Product Change Notification

Date Issued :	March 09, 2022	PCN Number :	511785
Reason for Change :	Obsolete		
Description of Change :	This notification is to inform you about the Obsolescence of part(s) referenced in this notice. Please connect with your Molex Sales Engineer for additional queries related to possible replacement part(s).		
Reason for Short Notice :	Special Request		
Planned Implementation Date :	July 11, 2022		
Recommended replacement parts :	Please see the attached replacement parts list .xls file.		
Last Time Buy Date for Obsolete Parts :	March 31, 2022		
Last Time Ship Date for Obsolete Parts :	June 30, 2022

Overview

Before Picture

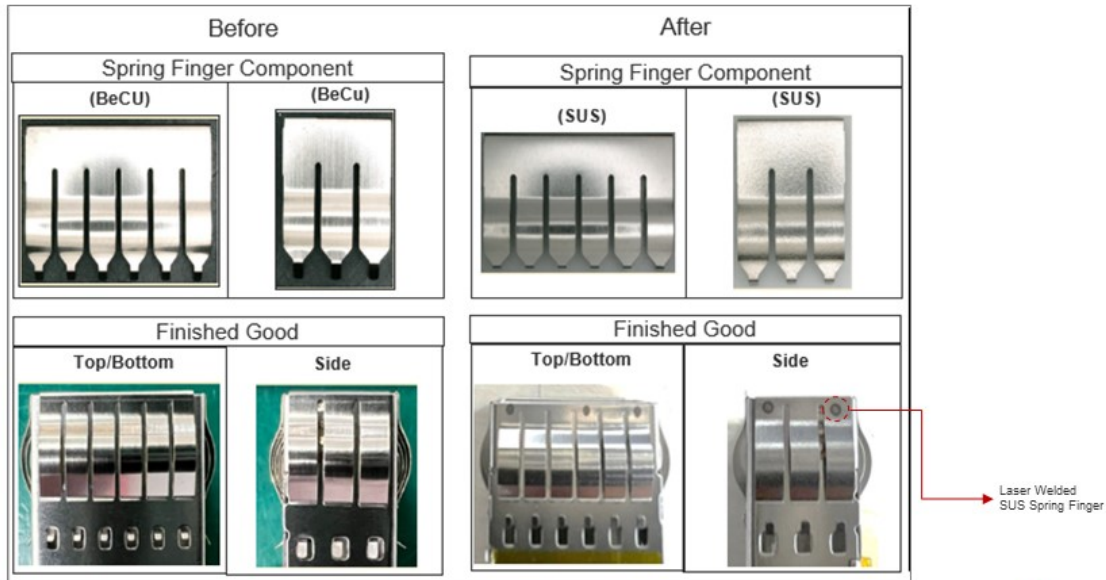
- Please be advised that the following Part numbers from the QSFP+/ZQSFP+ Ganged cages product families are being made Obsolete with replacement. The spring fingers of the offered replacement parts will be made of Stainless Steel & will also undergo laser welding during the assembly process.

- Reason for Change
Critical shortage of Beryllium Copper which is the raw material used in spring fingers of the affected parts.

- Product Impact
Spot welds will be the only effect to the form, no impact on fit or function based on test summary 1000143001 (available upon request).
